APPLICATION NO.	FILING DATE	FIRST NAMED INVENTOR	ATTORNEY DOCKET NO.	CONFIRMATION NO.
09/935,352	08/21/2001	Larry A. Coldren	510015-269	9440

**Office Action Summary**

## **DETAILED ACTION**

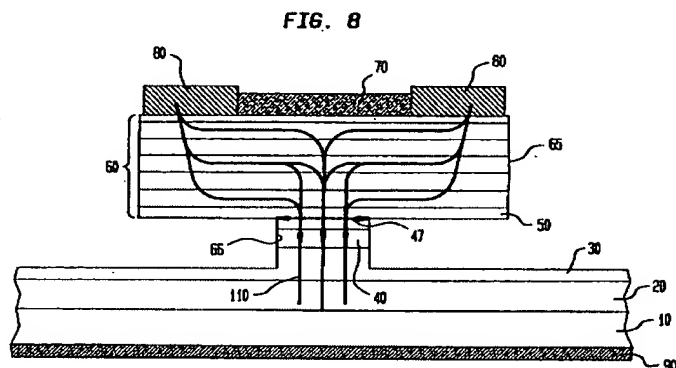
12. Claims 1, 4-16, 18-19, 22, 24-27, 29, 31-32, 35-42, 44, 47-66 are rejected under 35 U.S.C. 102(b) as being anticipated by Jewell et al (5,245,622). Jewell discloses the claimed invention. Note figures 8, 10 which shows an aperture of a VCSEL formed by

selective etching (see col. 8 lines 32-55).

aperture 47. Alternatively, as shown in FIG. 8, a vertical mesa etch followed by a selective lateral etch of the active region and surrounding layers can also be used to define the current aperture and isolate the device. Side-walls 65 and 66 are defined by a vertical mesa etch and a lateral selective etch, respectively.

Other advantages can also be gained in the process of FIG. 8. Since the diameter of the device shown in FIG. 8 is typically between 4-10  $\mu\text{m}$ , the carrier lifetime will be seriously reduced by non-radiative recombination at the periphery of the active region. When this region is defined by ion-implantation, there is no known way to obviate this problem except by a high temperature anneal which might also reduce the effect of the implantation and, hence compromise the structural integrity of the device.

When a mesa is etched to the level of the active material, it is possible for the lateral etch to include a passivation of sidewall 66 of the active material. This passivation preserves the carrier lifetime, reduces the non-radiative recombination and, therefore, results in a lower threshold current and increased optical quantum efficiency.
